PLANNIG COMMISSION MEETING STAFF REPORT

DATE OF MEETING: August 12, 2025

NAME OF PROJECT: Julian Subdivision

AGENDA ITEM: Plat Amendment

RLJ SMALL SUBDIVISION

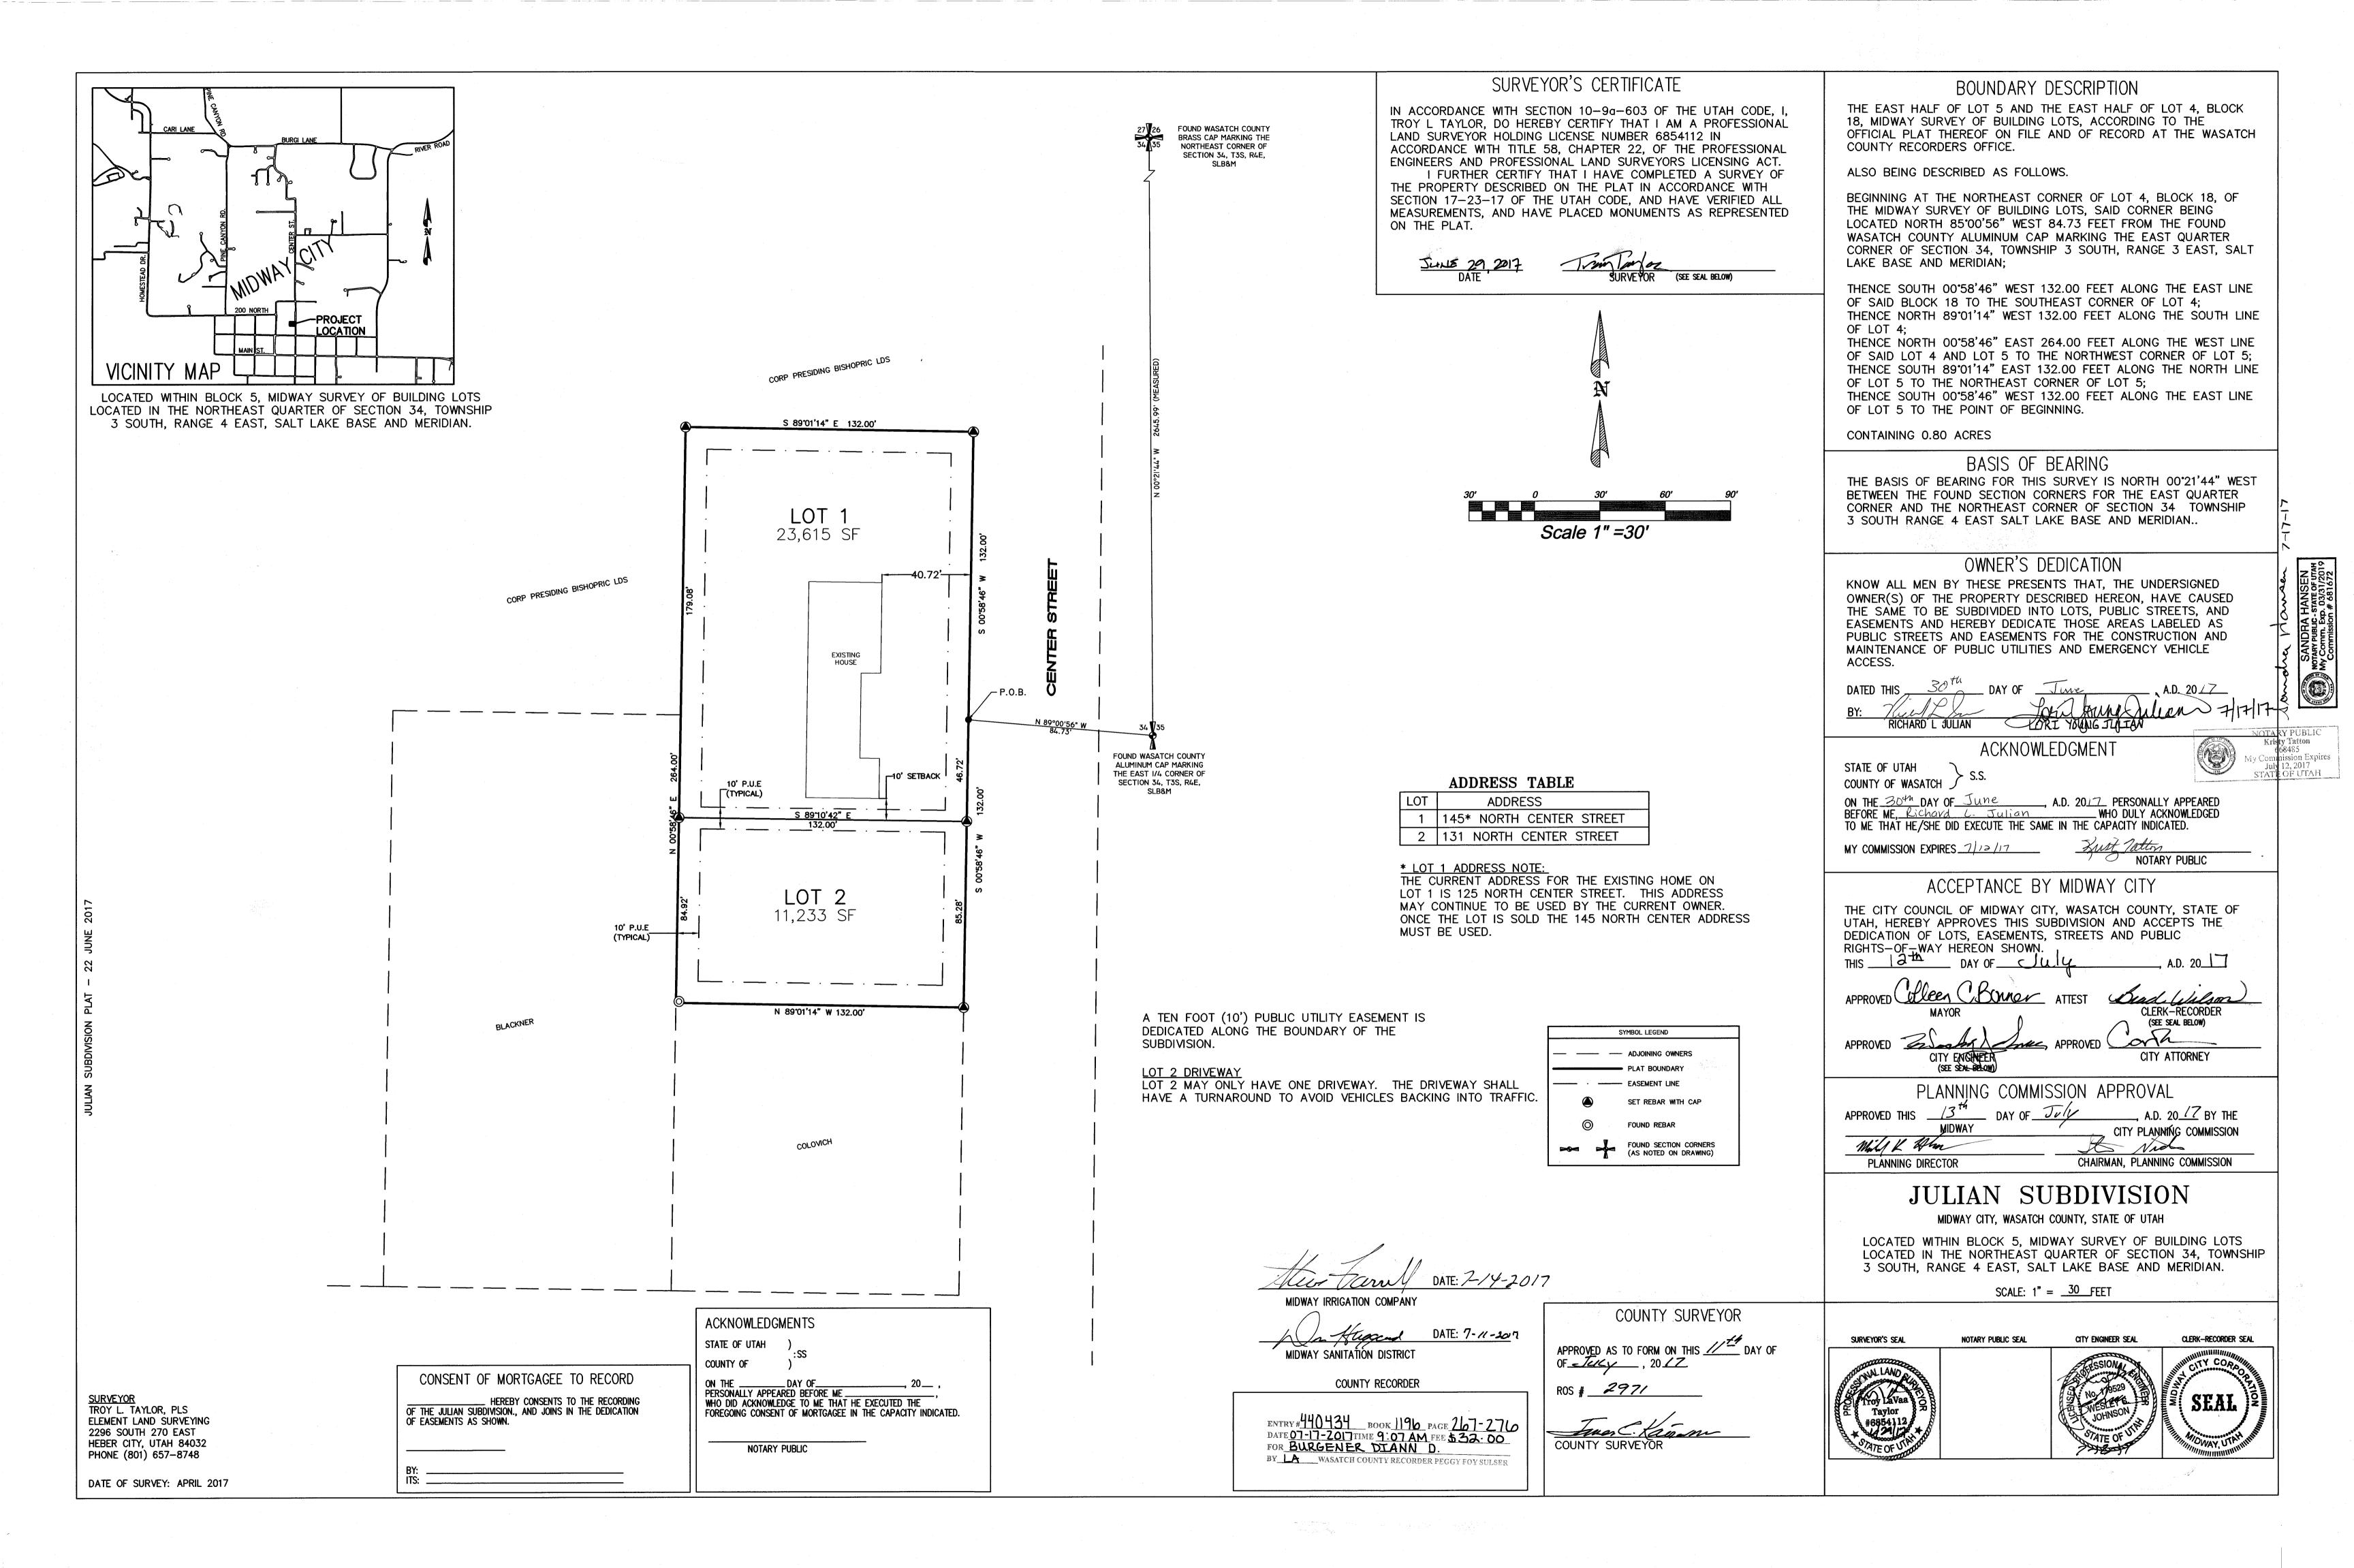
Public Utility Easement: A public utility easement currently runs along the perimeter of the subdivision and along the shared lot line of Lots 1 and 2. The same public utility easement should run along the boundary between Lots 1 and 3 if the application is approved.

Driveway: Per the existing Plat, the existing Lot 1 is limited to one driveway with a turnaround to avoid vehicles backing into traffic. A similar note should be placed on the plat for any new Lot 3, limiting Lot 3 to one driveway with a turnaround to avoid vehicles backing into traffic on Center Street.

Name: The original Plat denotes the subdivision name as the "Julian Subdivision". The proposed amended Plat lists the name as the "RLJ Small Subdivision, Amending Lot 1 of the Julian Subdivision". To avoid confusion, particularly for County rescue services, the name should remain "Julian Subdivision" and any amended plat revised accordingly.

- 1. Any amended plat will retain the name of the subdivision as the "Julian Subdivision". If Lot 1 is divided into two lots, the northern lot shall be denoted Lot 3 and the southern remain Lot 1.
- 2. Lot 1 shall continue to be restricted to one driveway access with a turnaround. A similar note shall be placed on the plat for the newly created Lot 3, restricting to one driveway with turnaround to avoid backing into Center Street.
- 3. Public utility easements of 10 feet will run along each side of the property line between Lots 1 and 3.
- 4. Water shares sufficient for the new Lot 3 will have to be dedicated prior to recording of any amended plat.
